CITY OF ONTARIO DEVELOPMENT ADVISORY BOARD

B. ENVIRONMENTAL ASSESSMENT AND DEVELOPMENT PLAN REVIEW FOR FILE NO. PDEV16-028: A Development Plan (File No. PDEV16-028) to construct a 32,276-square foot industrial building on 1.14 acres of land, located at the northeast corner of Mission Boulevard and Benson Avenue, at 1560 West Mission Boulevard, within the IL (Light Industrial) zoning district. Staff has determined that the project is categorically exempt from the requirements of the California Environmental Quality Act (CEQA) pursuant to Section 15332 (Class 32, In-Fill Development Projects) of the CEQA Guidelines. The proposed project is located within the Airport Influence Area of Ontario International Airport (ONT), and was evaluated and found to be consistent with the policies and criteria of the ONT Airport Land Use Compatibility Plan (APN: 1011-221-16); submitted by Lee & Associates. Planning Commission action is required.

FILE NO. PDEV16-028 DEPARTMENTAL CONDITIONS OF APPROVAL

Exhibit C: Elevations

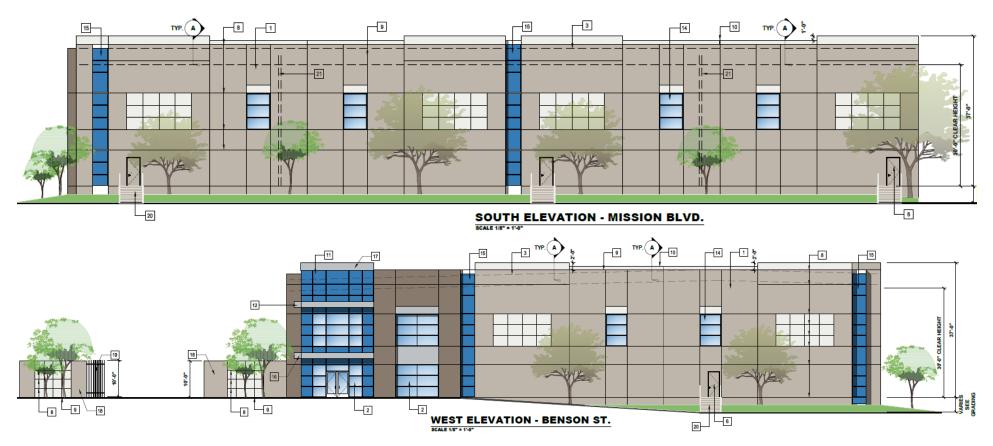
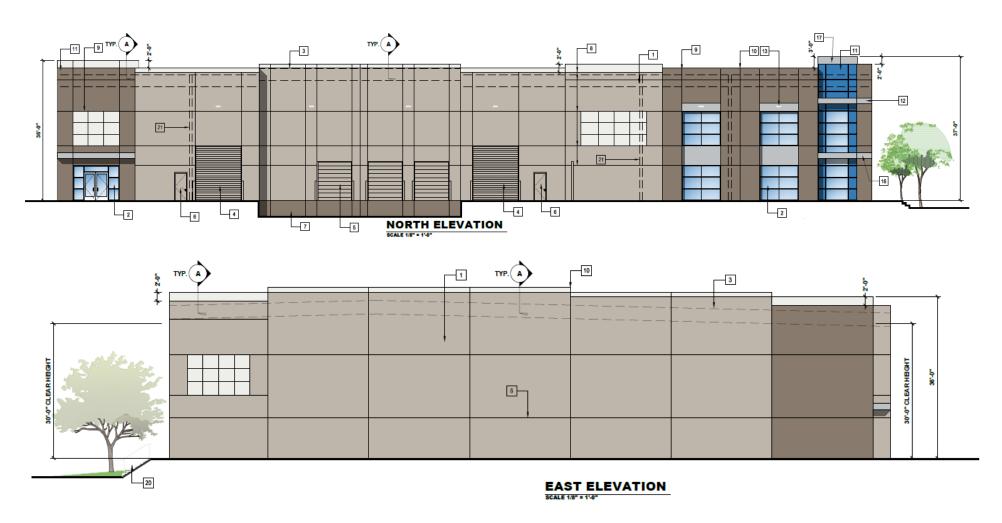
2.15 <u>Additional Requirements</u>. Incorporate color blocking on the south (Mission Boulevard) exterior elevation to the satisfaction of the Planning Director, to emphasize the four wall panels incorporating a vertical change in the parapet height.

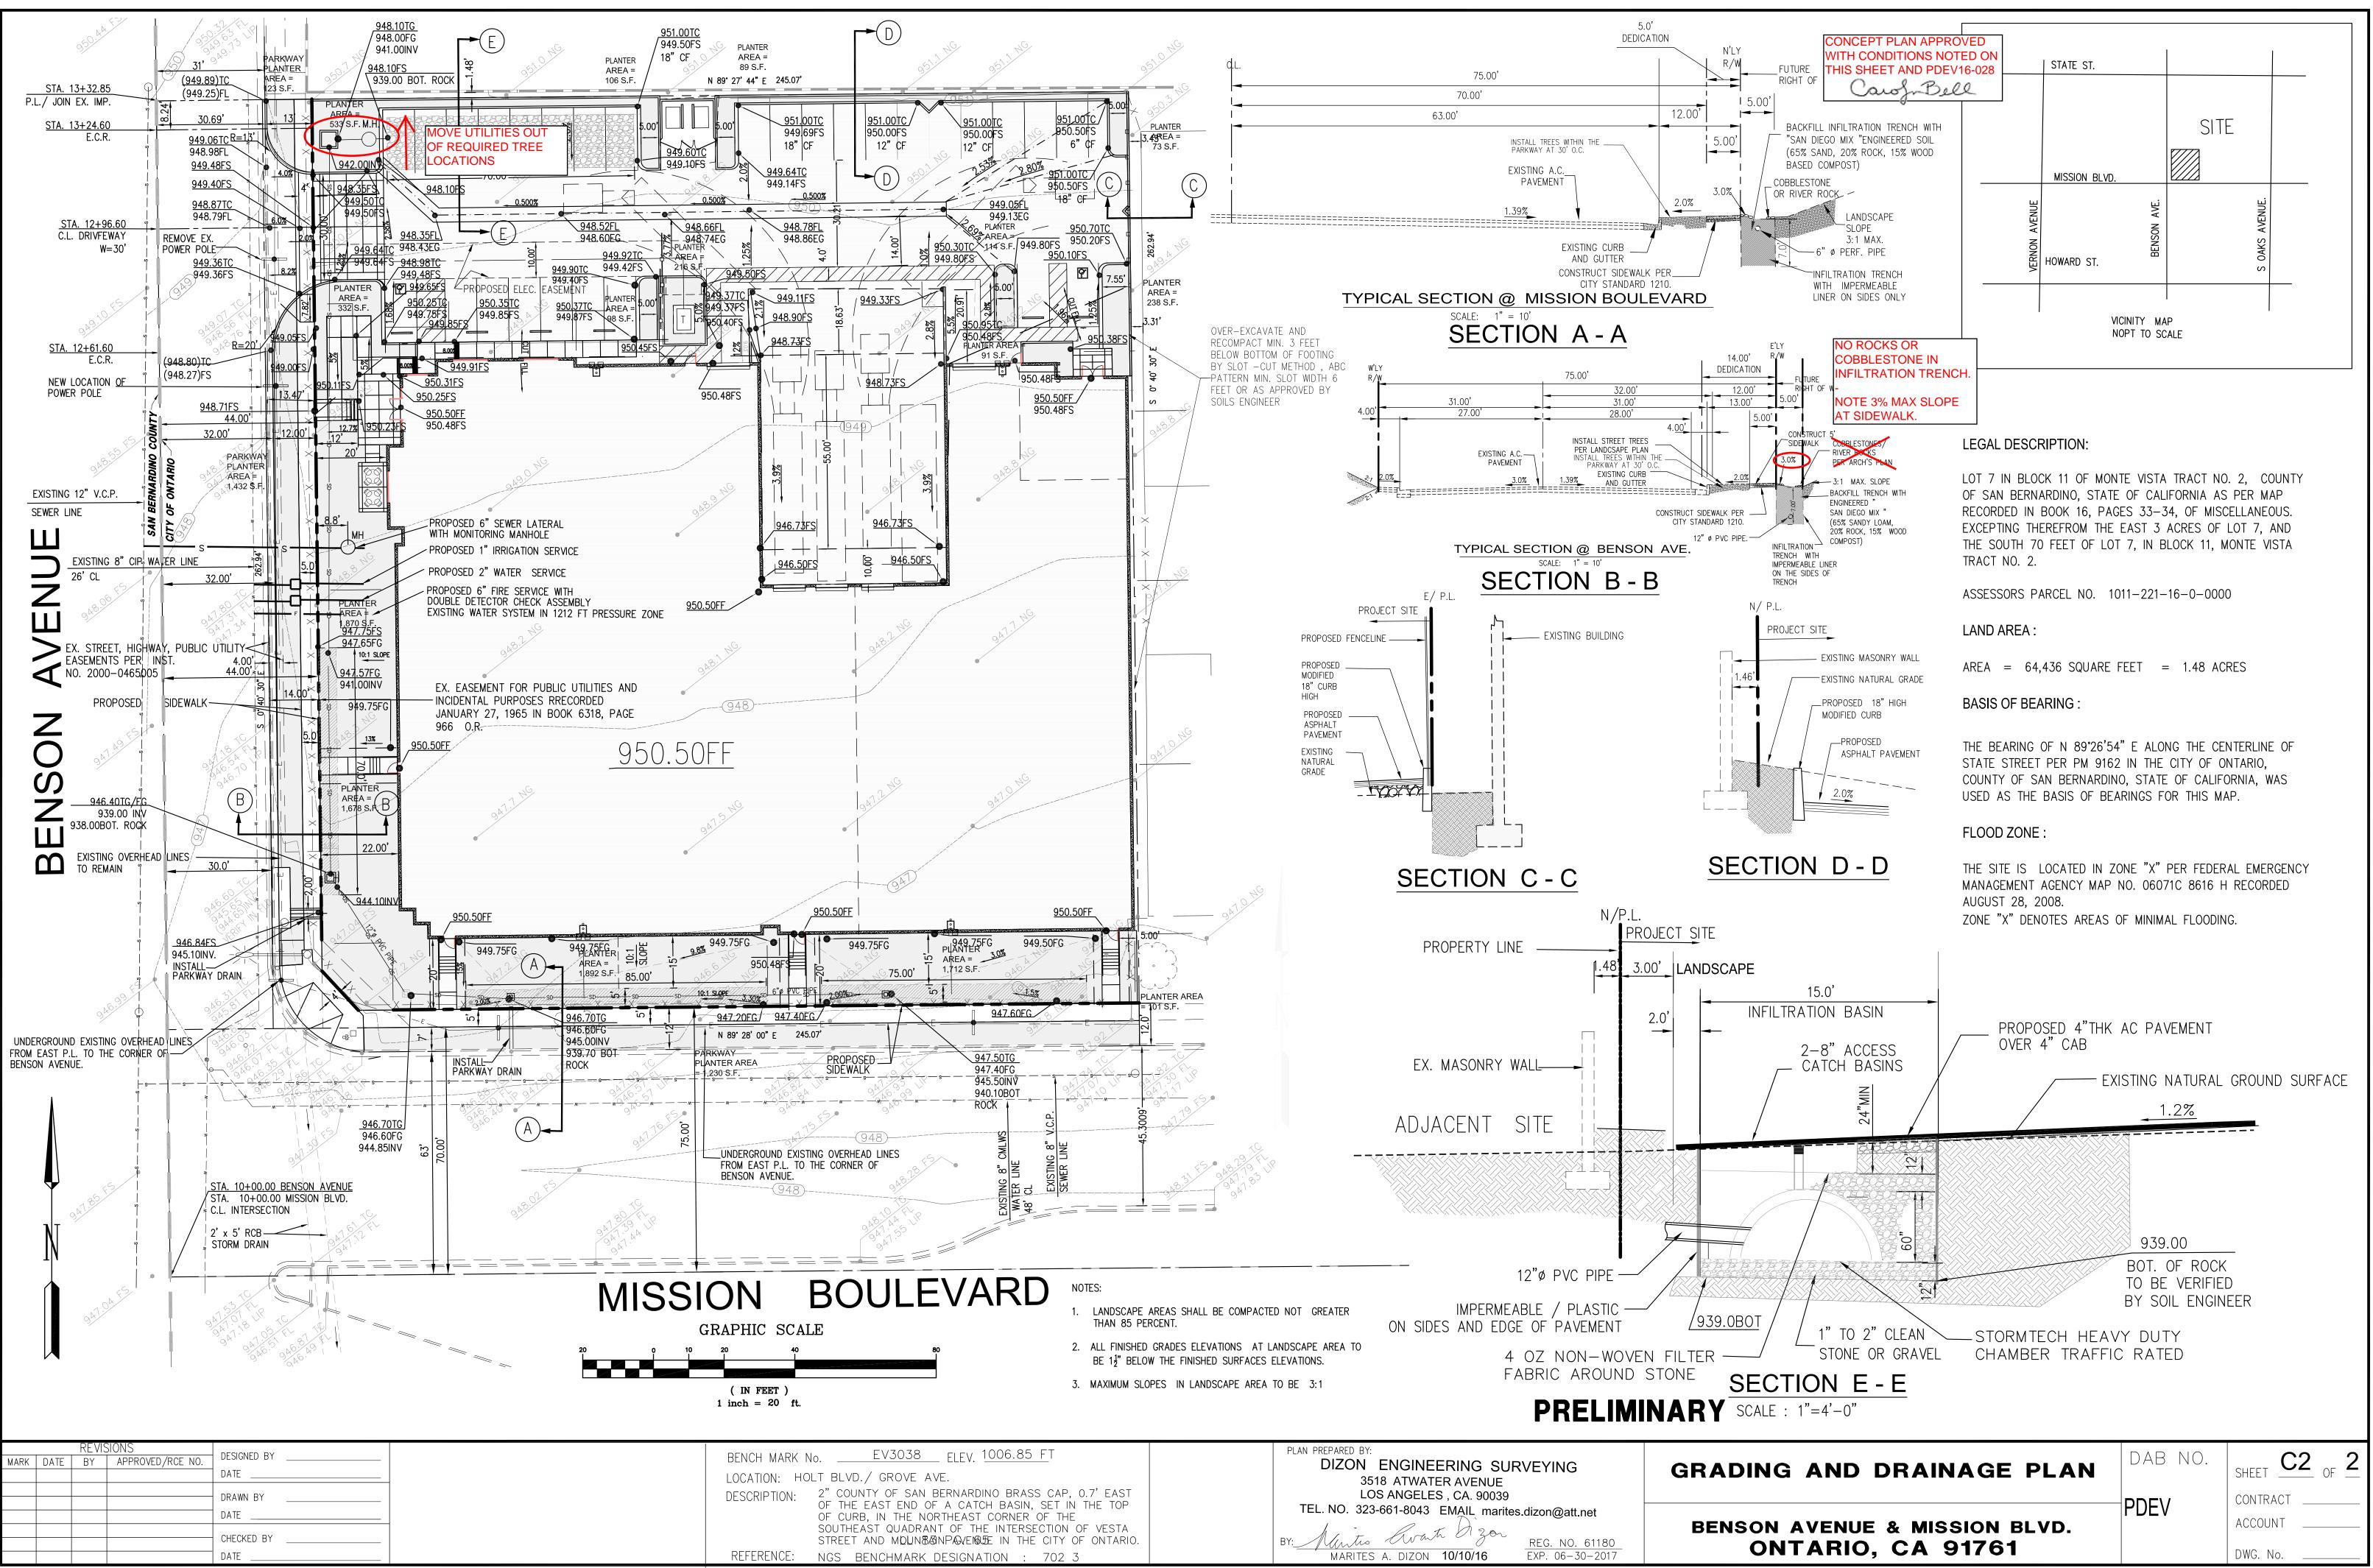
- 1. Note max 3% slope for swale adjacent to sidewalk.
- 2. Remove note for rocks or cobblestones at infiltration trench.
- Move utilities out of required tree locations NW corner of site. Move north min 6'. 3.

- 4. Show parkway landscape (max 18" high) and street trees for Mission Blvd; Quercus agrifolia centered in the parkway and Eucalyptus leucoxylon behind the sidewalk, 30' on center, triangulated with parkway trees.
- 5. Show a mass of shrubs to screen equipment to match on site landscape massing. Do not circle the equipment.
- Construction plans shall be designed and signed by a licensed landscape architect. 6.
- 7. Note for agronomical soil testing and include report on landscape construction plans.
- 8. Construction plans shall meet all requirements of the Landscape Development Standards.
- After a project's entitlement approval, the applicant shall pay all applicable fees for landscape plan 9. check and inspections at a rate established by resolution of the City Council. Typical fees are:
